Number: FS-2016-05

Model: **Diesel, CNG & BAE Hybrids With Starters**

Subject: Starter B+ Cable & Stud Maintenance

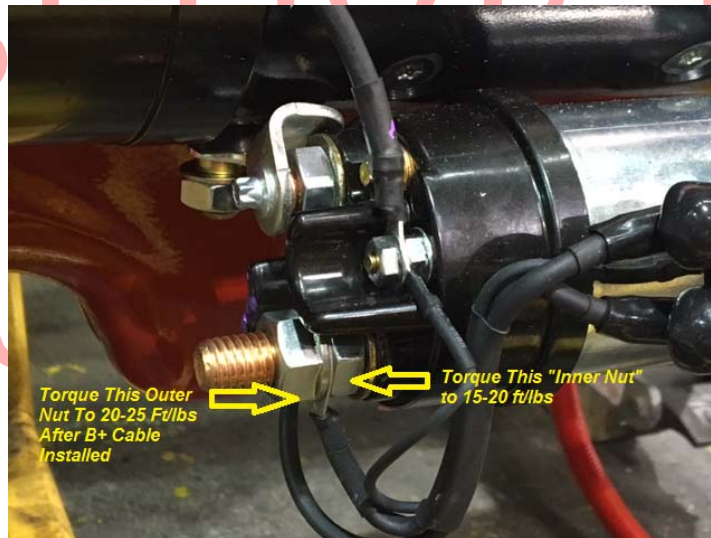
**Based on new information provided by Borg Warner, (Delco), we are revising the Starter Maintenance procedure B+ cable maintenance and torque values.**

- A. Inspect solenoid cap for damage or cracks.**
- B. Verify torque of outer nut at 20-25 ft lbs.**
- C. Re-coating of the stud with Kopr-Shield or any other anti-corrosion substance is optional, but if the B+ cable nut (outer nut) is removed, the inner nut should be held with a backing wrench, or re-torqued to 15-20 ft lbs).**
